**DIVISION OF RATEPAYER ADVOCATES
CALIFORNIA PUBLIC UTILITIES COMMISSION**

REPORT ON THE SUNRISE POWERLINK

San Diego Gas & Electric Company (SDG&E)

**Phase 1 Direct Testimony
Volume 3 of 5**

FIGURE 2-1

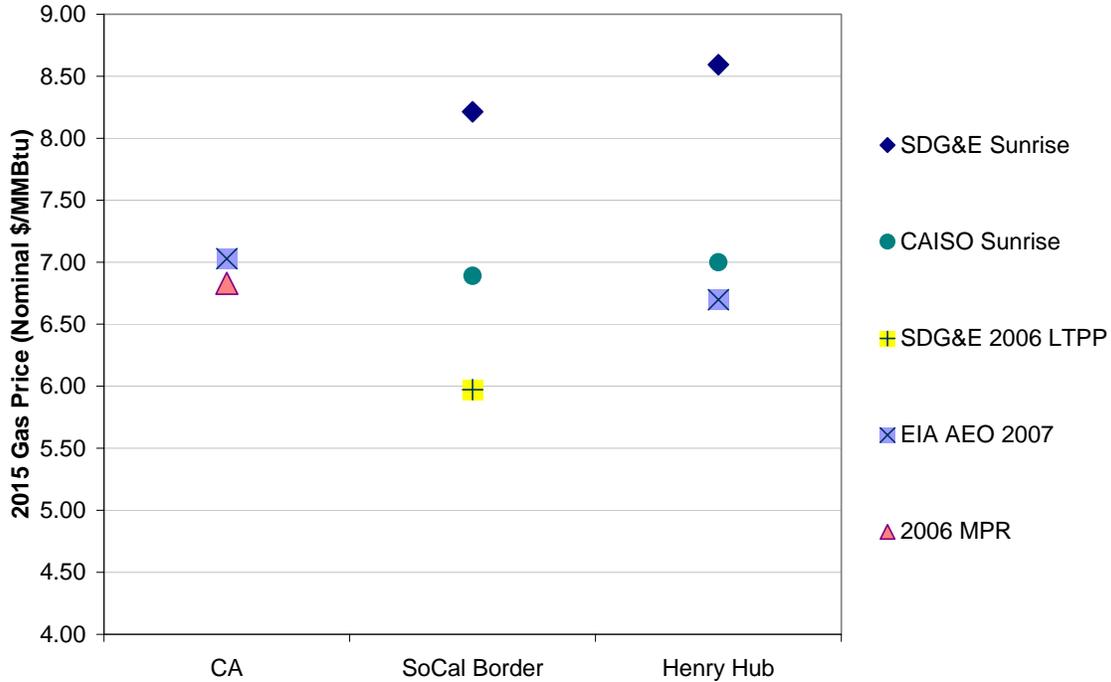
1 28 percent (or \$1.89/MMBtu (2015\$)) higher than the EIA’s Annual Energy Outlook
2 2007 forecast⁵ and 27 percent (\$1.85/MMBtu) higher than the gas prices used to compute
3 the Commission’s 2006 Market Price Referent.⁶ I also compared the gas prices SDG&E
4 submitted with its 2006 Long-Term Procurement Plan (LTPP) to the gas prices SDG&E
5 used in its analysis of Sunrise.⁷ SDG&E’s implicit SoCalBorder price in its Sunrise
6 analysis is 38 percent (or \$2.24/MMBtu) higher than SDG&E’s LTPP gas price forecast.⁸
7
8 Based on this simple survey, SDG&E’s gas prices do not appear reasonable for use in
9 base case modeling, but are better suited instead for a “high” gas price sensitivity. Figure
10 2-1 below illustrates the issue.
11

These high gas prices have a significant impact on estimated energy benefits. Gas prices drive much of the claimed Sunrise energy benefits.

For example, using the CAISO's gas price assumptions along with all the other assumptions from SDG&E's analysis causes energy benefits to fall approximately \$46 million, or 44 percent.^{9,10} This sensitivity identifies one of the main assumption differences between CAISO and SDG&E energy modeling results.

FIGURE 5-1³³

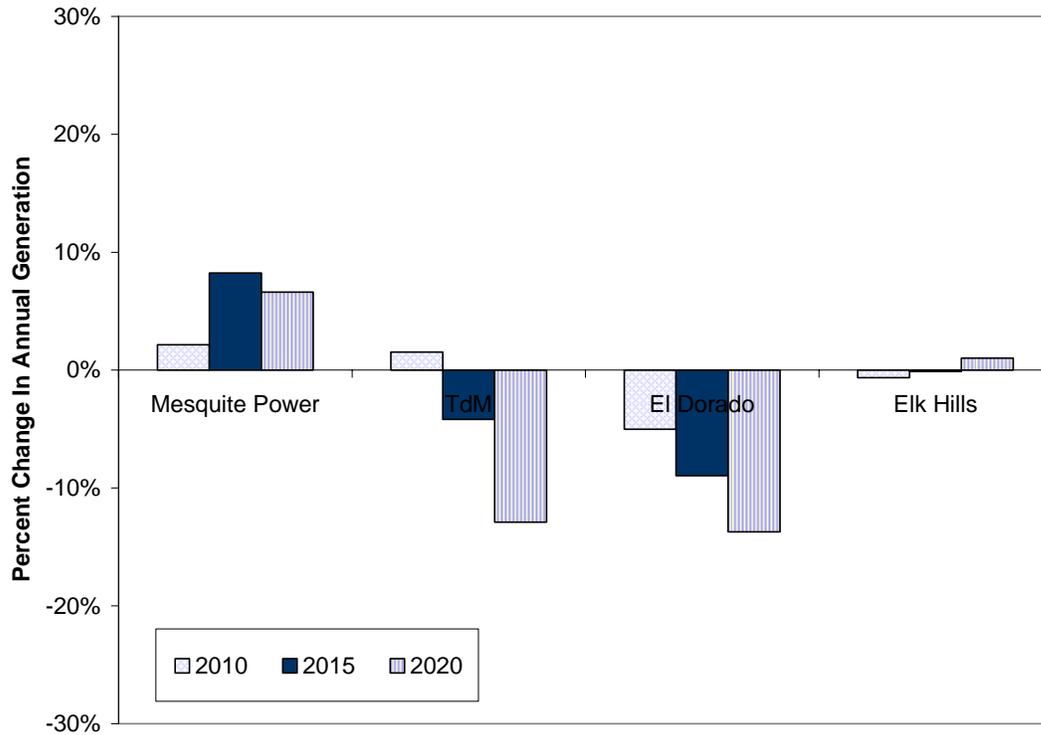
2
3 DRA also considered the impact of Sunrise on Sempra Generation’s 2,630 MW of
4 generation capacity located in California, Arizona, Nevada and Mexico. SDG&E’s
5 modeling shows dispatch from the Sempra Generation portfolio increases 1 percent in the
6 Sunrise Case over the Base Case for 2010 and 2015 and decreases 3 percent in 2020.
7 Figure 5-1 shows the same information but on a plant-by-plant basis. The Sempra plant
8 most affected by the Sunrise project would be Termoeléctrica de Mexicali (TdM), which
9 interconnects directly with SDG&E’s Imperial Valley Substation. It shows a small
10 increase in generation in 2010, a 4 percent drop in 2015 and a 13 percent decrease in
11 2020.

12
13 However, SDG&E’s modeling shows net revenues moving almost in an opposite
14 direction to dispatch, with portfolio net revenues increasing modestly in 2010 and 2015
15 (\$0.40/kW-year and \$0.78/kW-year, respectively) and more substantially (\$4.70/kW-
16 year) in 2020. Table 5-1 below summarizes these results.
